**SUBJECT:** **Safety Recall 05S28 - Supplement #14:** 1992-2004 Multiple Vehicle Lines - Speed Control System Modification

**REF:** Safety Recall Bulletin 05S28 Supplement #13 dated September 5, 2007

**New! REASONS FOR THIS SUPPLEMENT**

FIGURE 1

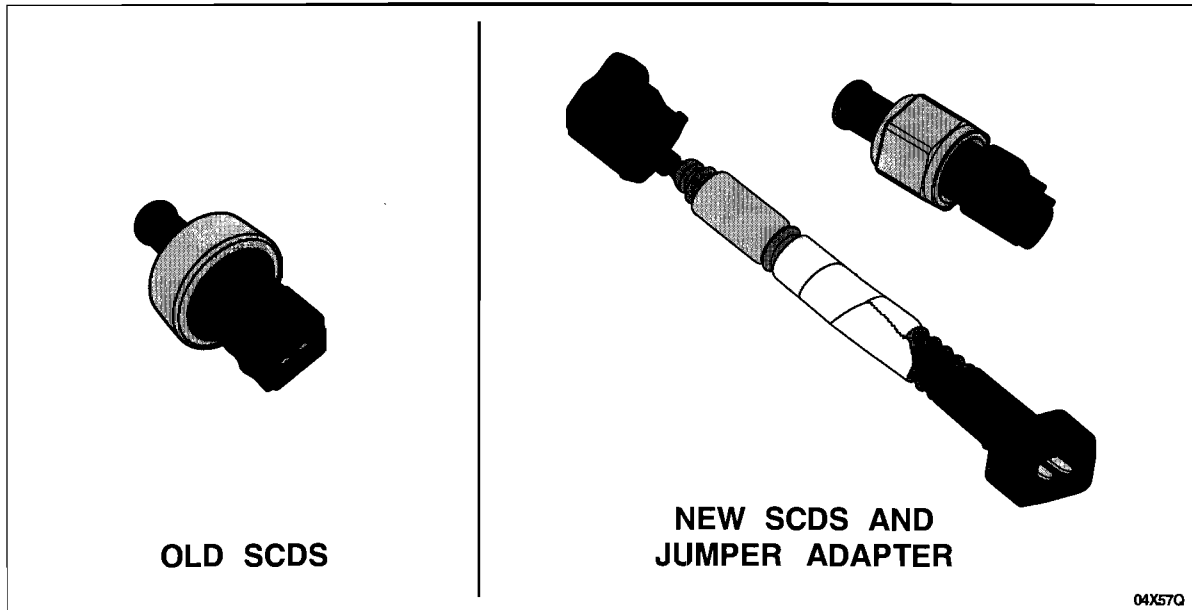
The Speed Control Deactivation Switch (SCDS) involved in Recall 05S28 and the revised SCDS is illustrated below. See Figure 1.

Note that the revised SCDS has a different electrical connector. A jumper adapter (which is included in the parts kit) is required when replacing the old SCDS with the revised SCDS.
